Consolidated Update

Dated 23rd April, 2024 – St George’s Day

1. The Long Sand Head (Page 119):

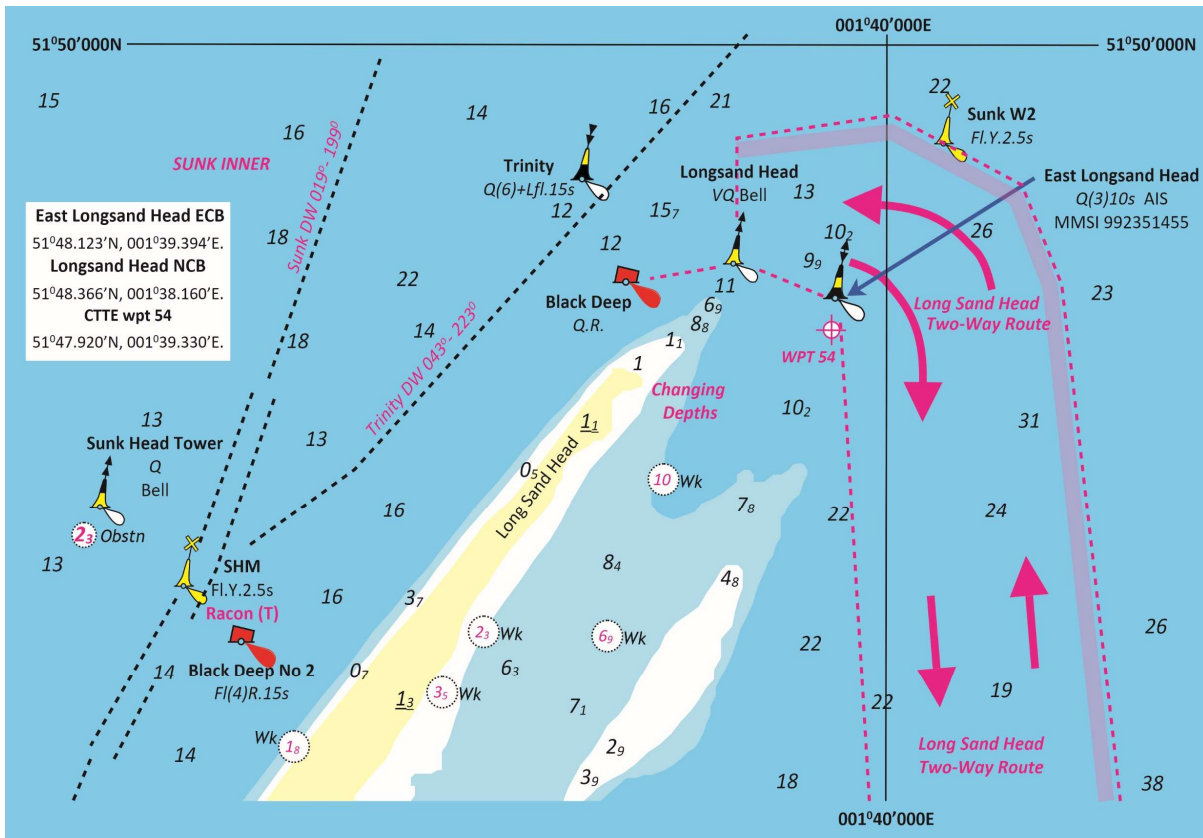
Trinity House have just issued a Notice to Mariners providing us advance notice of changes at the Long Sand Head. The changes are planned to be actioned “on or around 17th May, 2024”. In the past 12 months, the Long Sand Head has continued gently, but persistently, to creep more to the northeast. For us there is no crisis but heed the warning not to ‘cut the corner’. For shipping using the Two-Way Route in and out of the Black Deep two changes have been necessary.

The creation of a new east cardinal buoy. This will be positioned very close to current position of the Longsand Head north cardinal buoy. The new buoy will be designated ‘East Longsand Head’. Characteristics are shown in the chartlet. Note it will have AIS.

The Longsand Head north cardinal buoy will be moved west and a little north. As you will see in the chartlet the effect is to make the corner clear for shipping. Characteristics for this buoy will remain as at present.

The only CTTE routes involved are Routes 26 and 31 (Page 119): the ‘Outside’ routes between Ramsgate and Harwich Harbour or the Deben. At the Long Sand Head, CTTE has Waypoint 54. I consider that, at present, there is no need for the waypoint to be moved. As you will see the waypoint is located clear of the Two-Way Route TSS yet has ample water for leisure craft.

SW Sunk swatchway 2023

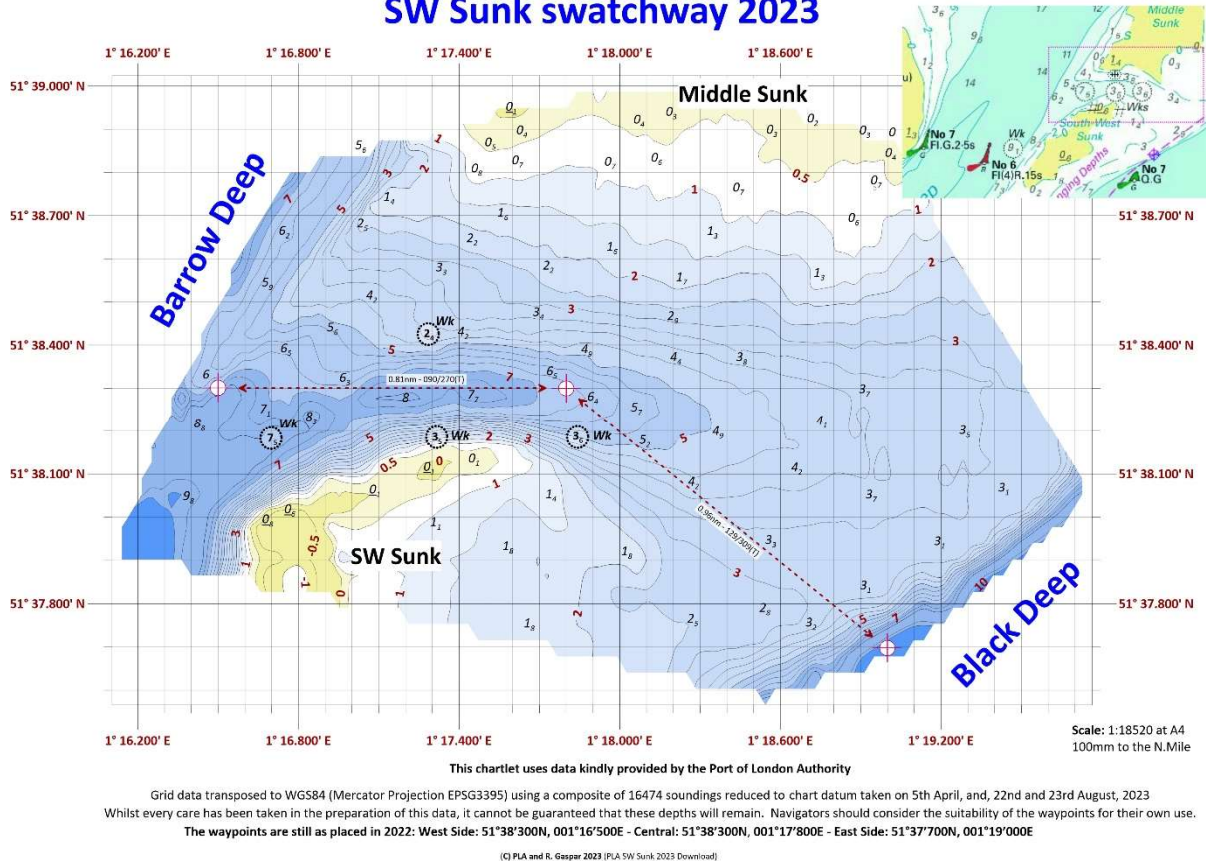
Courtesy of some excellent work by the Port of London Authority, we can update on the SW Sunk. The short message is that the 'object' found this year in the swatch is a wreck and there is 2.4m CD over it, the SW knoll has been stable (i.e. it has not moved much if at all) and the SW edge of the Middle Sunk sand has continued to retreat (i.e. usable water in the swatch is wider).

The PLA work involved a multi-beam survey investigating the wreck and the SW edge of the Middle Sunk. That provides very detailed data and it is very kind that the PLA have allowed me to use the full XYZ data. As a result I have finished a new chartlet which can be downloaded at:

The conclusion is that the swatch remains feasible and whilst we will, of course, go back down there again next Spring, we would be very surprised if there was a problem. The three waypoints remain fine.

1. The Ray Sand (Page 212/213):

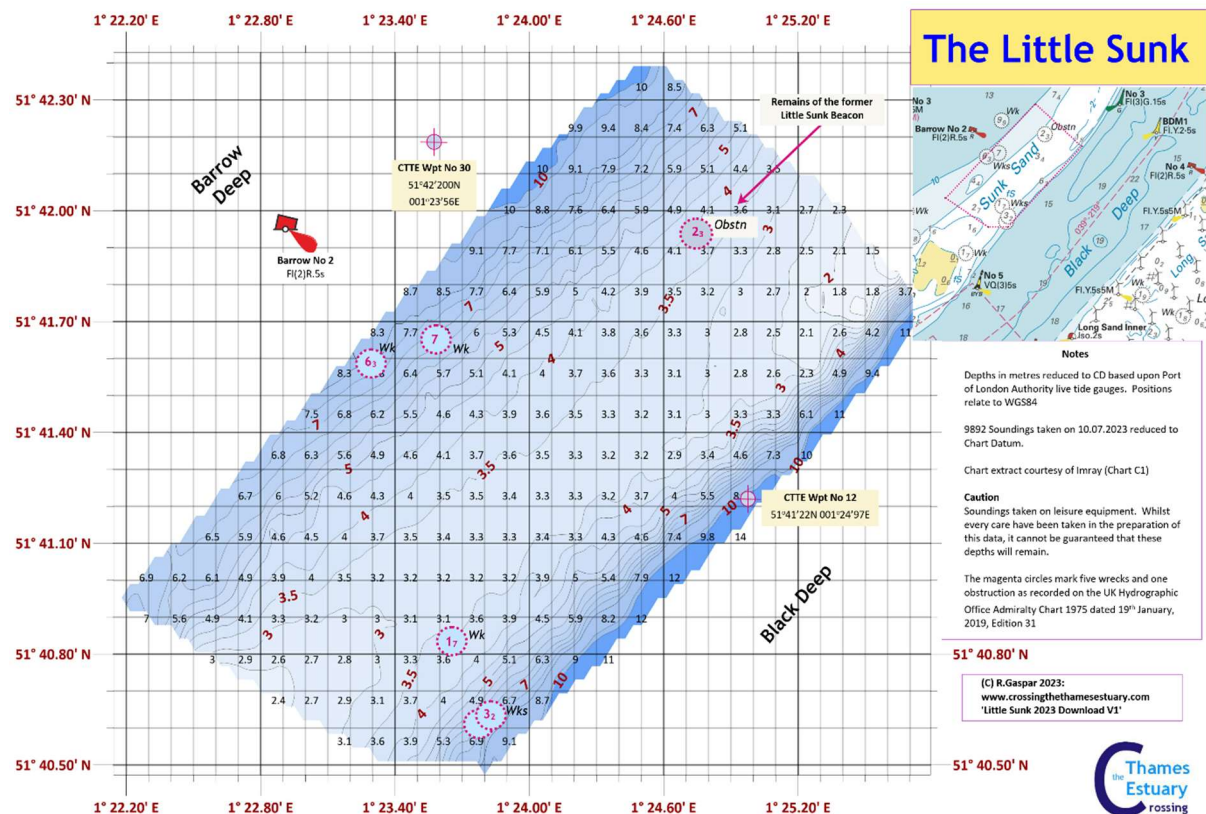
On 13th July, 2023, the Crouch Harbour Authority reported changes for the buoyage for the Ray Sand.

- ⊕ The Ray Sand Middle safe water buoy is permanently withdrawn.
- ⊕ The Ray Sand North is now a Special Yellow Unlighted Pillar Buoy and is located at **51°40'.81N., 001°00'.57E.**
- ⊕ The Ray Sand unlighted yellow buoy is now located at **51°39'.84N., 001°00'.57E.**

The buoyage now reflects the recommended crossing place (i.e. the shortest and least drying heights over the sands). I have updated the Ray Sand chartlet to reflect the changes. You can download it at:

2. The Little Sunk crossing point (Page 24):

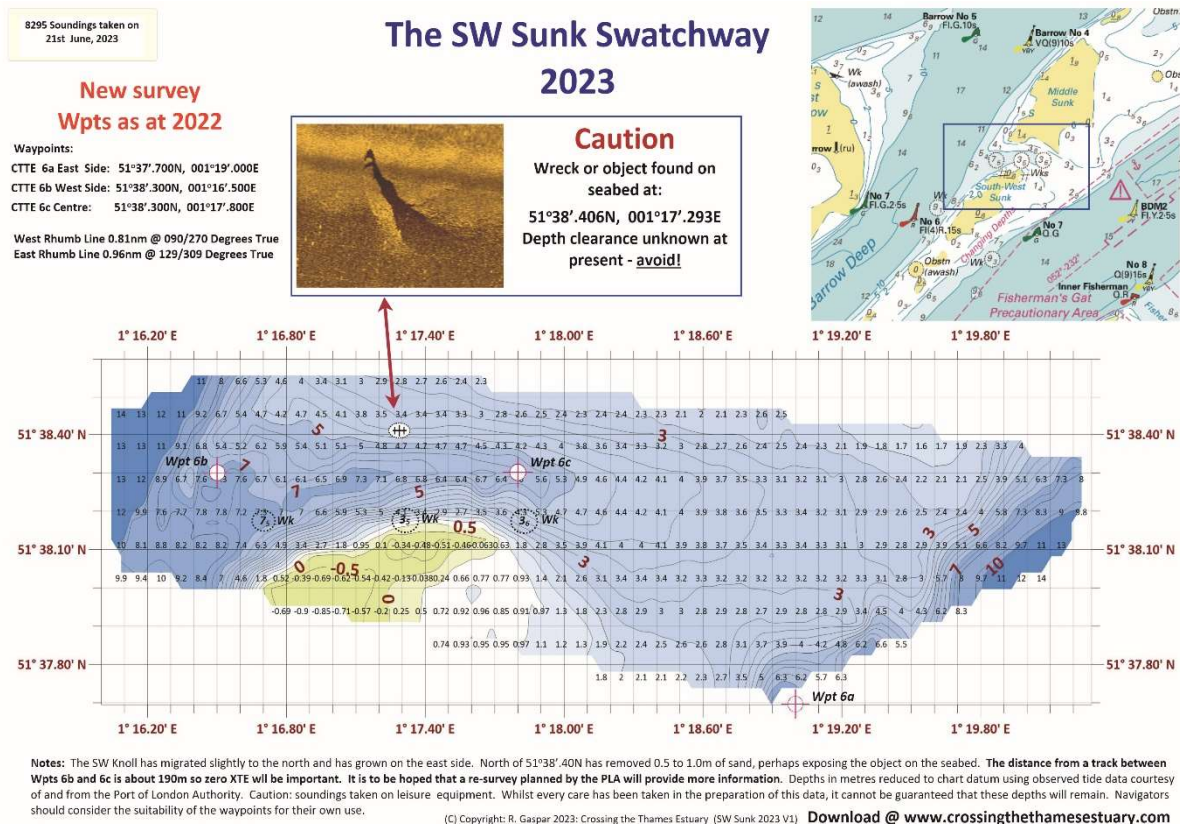
On 10th July, 2023 we completed a successful survey at the Little Sunk. We thought conditions might be unsuitable but to our surprise locally we had 4 to 7kts of wind and was perfect. The results are good, little change; in the central area there is 3.2m CD minimum.

Waypoint 12 is positioned to use either to or from the Essex or Suffolk Rivers but when you studied the chartlet you can there is plenty of 'room' to adjust where exactly you cross. Download the new chartlet at: <https://www.crossingthethamesestuary.com/page29.html> (scroll down to item 5)

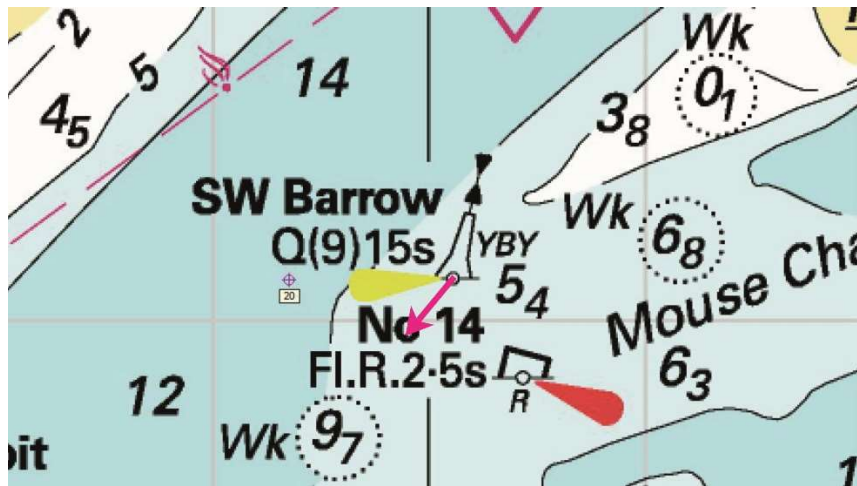
1. The Ray Sand: We have completed two surveys of the Ray Sand in August and September. As a result I have completed a new chartlet you can download at:
<https://www.crossingthethamesestuary.com/page29.html> (scroll down to item 4)

The chartlet is largely as the image Page 213 but the scale has a lot more detail. The sands have not changed significantly but our surveys extended further to the west and east of the line of buoys. The 1° degree meridian remains, in my view, the best 'water' and the survey shows that staying east of the 1° degree meridian is good.

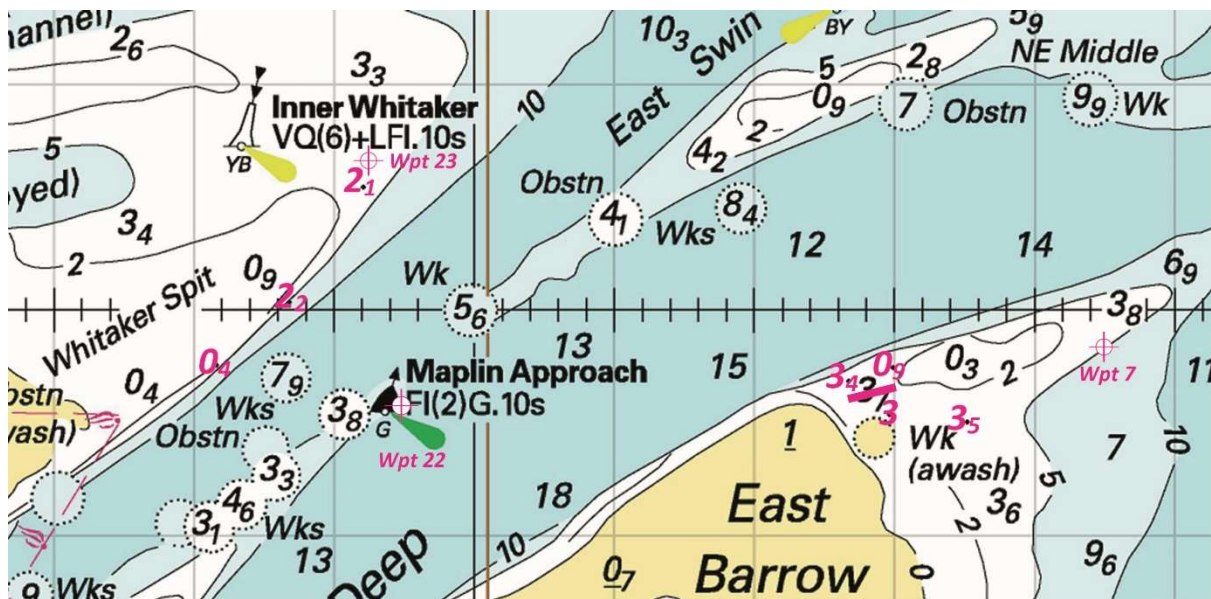
3. Whitaker Spit and the East Barrow Sand: As a result of a Port of London Authority survey earlier this year, the UKHO issued a Notice to Mariners two weeks ago notifying reduced depths at the Whitaker Spit (3) and the East Barrow Sands (4). The image shows the results and waypoints 7, 22 and 23:

If passing either direction between waypoints 22 and 23 bear in mind the height of tide over the edge of the Whitaker Spit. If heading to and from the SW Sunk swathway bear in mind that waypoint 7 remains fine. Some have cut the corner of the East Barrow Sand between the 'north east finger' and the main sands. It remains feasible with care. NOTE that Navionics have not yet updated their chart (as at 14.09.22). I am unable to say where C-Map or others have updated these changes.

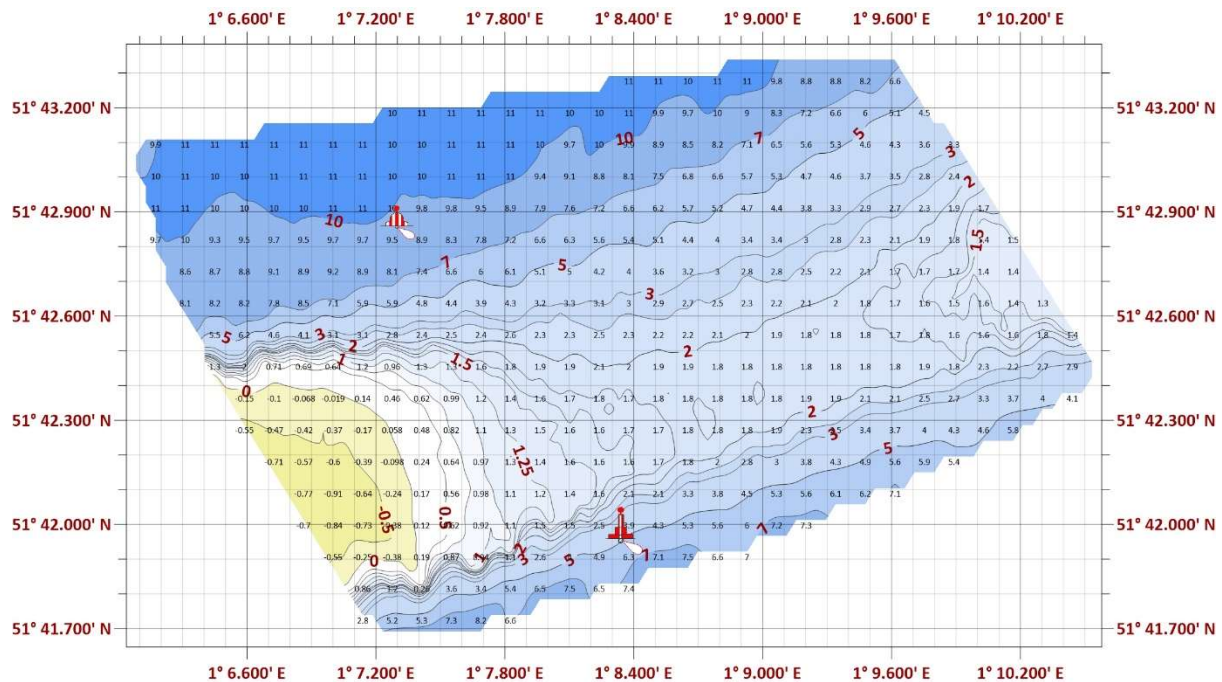
1. The Spitway: On the 30th May, we conducted a survey of the Spitway. Lovely flat conditions during the process which was very convenient and makes accuracy simple. The conclusion is that the swathway has changed very little. It remains the best water to the east of the safe water buoys at 1.8m at chart datum. There is a new download comprising the chartlet and some notes and profiles at:

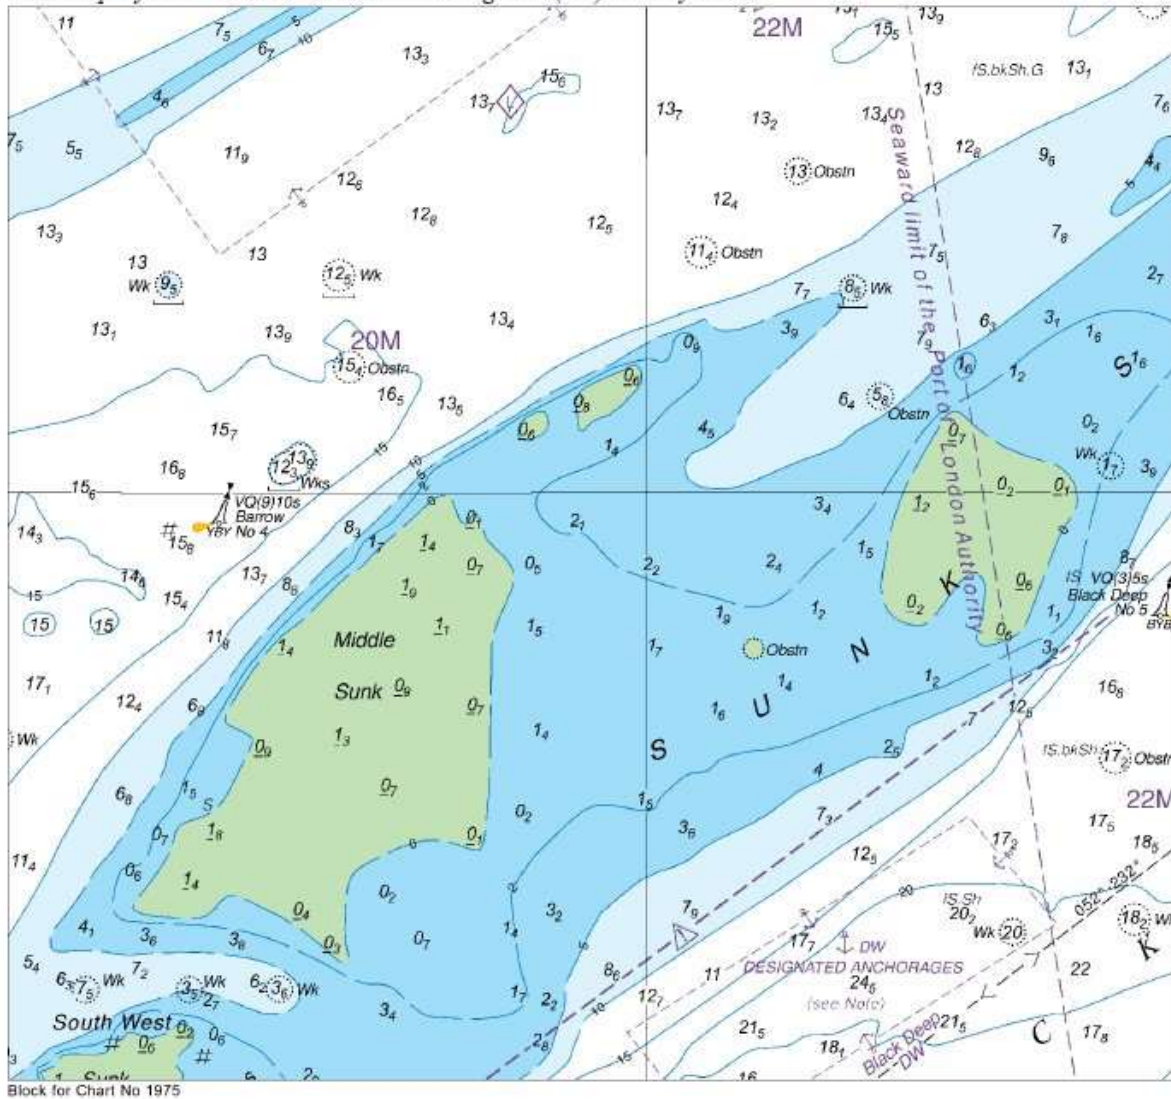
2. SW Sunk swatchway: We completed a re-survey on 18th May, 2022. The swatchway remains entirely useable (and indeed has been).

The swatchway is, though, subject to some changes. The SW Knoll is the most significant feature there and I consider the drying part of the knoll has migrated further to both the north and east. Because of the movement to the east we noticed that the tide rip that occurs in the flood tide did extend further. Because of the north and east movement I am recommending that the mid waypoint should be moved in a similar way.

Revised recommendation – Wpt 6c - 51°38'300N, 001°17'800E. Wpts 6a and 6b remain as before.

The tide does run quite hard through the swatch. In the last hour of the flood we still experienced a 2 kt east to west tide close to the edge of the SW Knoll – hence the tide rip. Following the track between the recommended waypoints will keep you well clear of the tide rip (which isn't there at all states of the tide). You can see an example of the tide rip taken in 2021: https://www.youtube.com/watch?v=5jimnl_ktjc I do stress though there is ample room to stay well clear of the rip.

I regard the mid point waypoint as fixed but 'frequent' users could moderate wpts 6a and 6b being aware of the depths.
